REPLACES AD-136 AD-140 Page 1 of 3

Airworthiness Directive: 140

Subject: Hour meter oil pressure switch leak

Models Affected: All RANS aircraft with ROTAX 912 series engines equipped

## Oil Pressure Switch Removal:

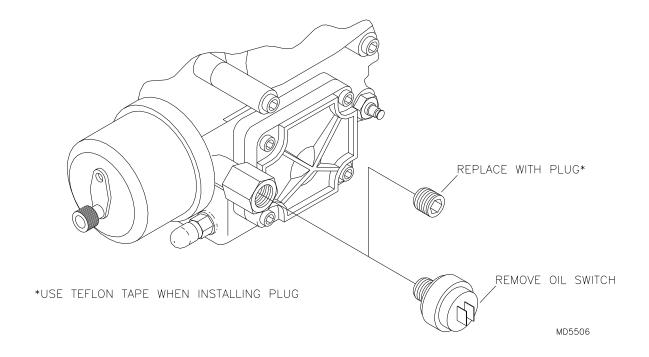
It has been brought to our attention that failures have occurred in the internal seal of the Oil Pressure Switch (RANS P/N KSES0004). This has caused premature loss of oil resulting in engine failure. Due to possible sudden failure of the Oil Pressure Switch the Hour Meter Relay and 1/8" Pipe Plug should be installed before next flight.

If the aircraft is equipped with Oil Pressure Switch (RANS P/N KSES0004), remove the aircraft from service until it is possible to replace the Oil Pressure Switch with an 1/8" pipe plug and install Hour Meter Relay Assembly.

1/8" pipe plug (RANS P/N PIPE-PLUG 1/8) Hour Meter Relay Assembly (RANS P/N KAES0016).
